# Access Compliance Report

## Public Rights-of-Way

Intersection ID: 28061	Main Street: CORRYSTONE_DR	Cross Street: WILLOW_ROCK_DR	Location: W
ADA ID: BB1711CD07AD	Ramp Type: PerpDiag	Initial Pass/Fail: Fail	Overall Compliance: No
Severity Score: 42.5			
Codes/Mitigation Info/Possible Solution		Field Measurements/Component Compliance

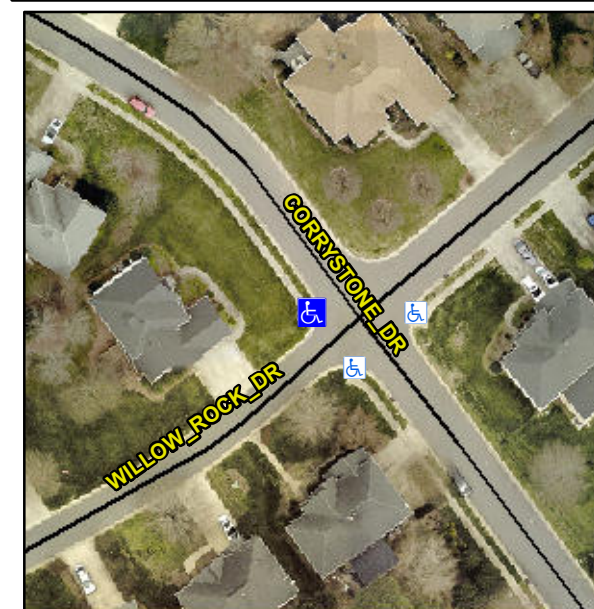
**Not Found, R304.5.1, R304.5.3**

Compliance	Description	Data	Compliance	Description	Data
N/A	Ramp Length (in)	48.0	Yes	Ramp Slope (%)	7.6
No	Ramp Width (in)	33.0	No	Ramp XSlope (%)	8.6
N/A	Flare Type LT	N/A	N/A	Flare Type RT	N/A
N/A	Flare Slope LT (%)	N/A	N/A	Flare Slope RT (%)	N/A
N/A	Flare Traversable LT?	N/A	N/A	Flare Traversable RT?	N/A
N/A	Landing Length (in)	N/A	N/A	DWS Provided?	N/A
N/A	Landing Width (in)	N/A	N/A	DWS Contrast?	N/A
N/A	Landing Slope (%)	N/A	N/A	DWS Length (in)	N/A
N/A	Landing X Slope (%)	N/A	N/A	DWS Full Width?	N/A
N/A	Landing Curb? (Y/N)	N/A	N/A	DWS Offset (in)	N/A
N/A	Shared Landing?	N/A			
N/A	Gutter Ponding?	N/A	N/A	Gutter Slope (%)	N/A
N/A	Gutter Lip Ht (in)	N/A	N/A	Gutter X Slope (%)	N/A
N/A	Painted X Walk1?	No	N/A	Painted X Walk2?	No
	X Walk 1 Direction	To SE		X Walk 2 Direction	To NE
N/A	X Walk 1 Width (in)	N/A	N/A	X Walk 2 Width (in)	N/A
	X Walk 1 Slope (%)	1.1		X Walk 2 Slope (%)	2.9
	X Walk 1 X Slope (%)	3.8		X Walk 2 X Slope (%)	2.4

**Remove & Replace Curb Ramp With Two New Directional Ramps or Equivalent.**
